NRC 2003-0050

DOCKETS 50-266 AND 50-301
POINT BEACH NUCLEAR PLANT, UNITS 1 AND 2
SUPPLEMENT 2 TO LICENSE AMENDMENT REQUEST 229
TECHNICAL SPECIFICATION LCO 3.5.2, ECCS – OPERATING,
AND LCO 3.5.3, ECCS – SHUTDOWN

**RESPONSE TO REQUEST FOR ADDITIONAL INFORMATION
LICENSE AMENDMENT REQUEST 229, SUPPLEMENT 2
TECHNICAL SPECIFICATION LCO 3.5.2, ECCS – OPERATING, AND
LCO 3.5.3, ECCS – SHUTDOWN
POINT BEACH NUCLEAR PLANT, UNITS 1 AND 2**

PACIFIC PUMPS DIVISION DRESSER INDUSTRIES, INC.			
TITLE PUMP ASSEMBLY			
DWG. NO.	CERTIFIED	DATE 8-23-90	
DWG. NO.	SIZE	PRODUCT, ENG. NO.	SHEET
SCALE		500-P45250	REV

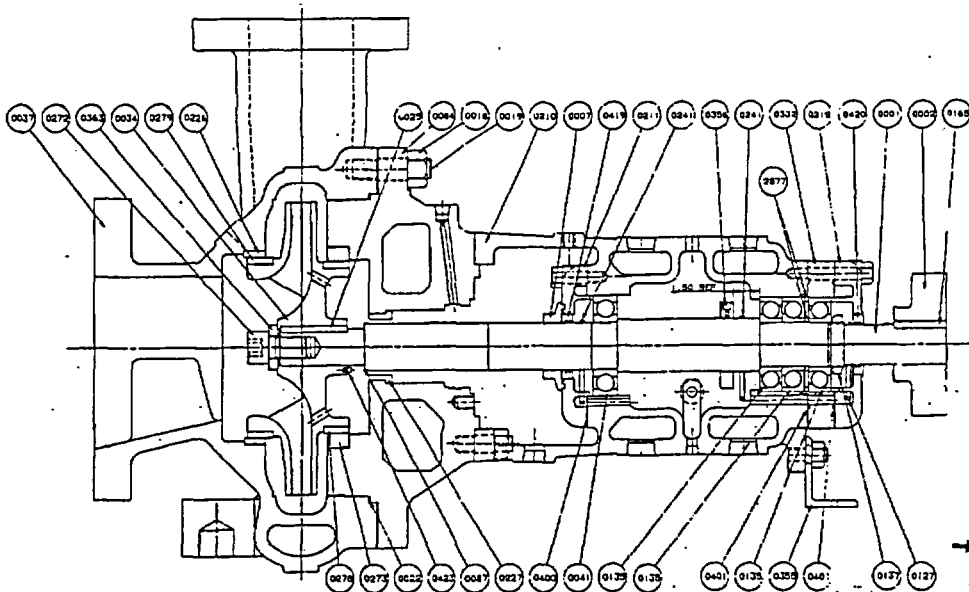
In page 4 of Attachment 1, you stated that RHR (residual heat removal) pump casings do not need to be vented because they are at system low points and because of their configuration. What is the location of the high point vents with the capability of venting the RHR pumps? Do you have any diagrams and/or information that will help us to understand the venting system?

Enclosures (b) and (c) to the letter transmitting this response provide Piping and Isometric Drawings of the Point Beach Nuclear Plant (PBNP) Auxiliary Coolant System and a RHR pump assembly drawing. The RHR pump casings are at the system low point and their configuration is such that gases are unlikely to collect there. The enclosed drawings show how the discharge volute of the RHR pump provides a direct path from the pump casing to the discharge piping. Gases that may come out of solution within the pump casing will likely rise up out of the casing and flow into the discharge piping due to the system configuration. The high point vents on the discharge piping are located to facilitate removal of this gas. Venting the accessible ECCS piping outside containment will minimize any voids and pockets of entrained gases.
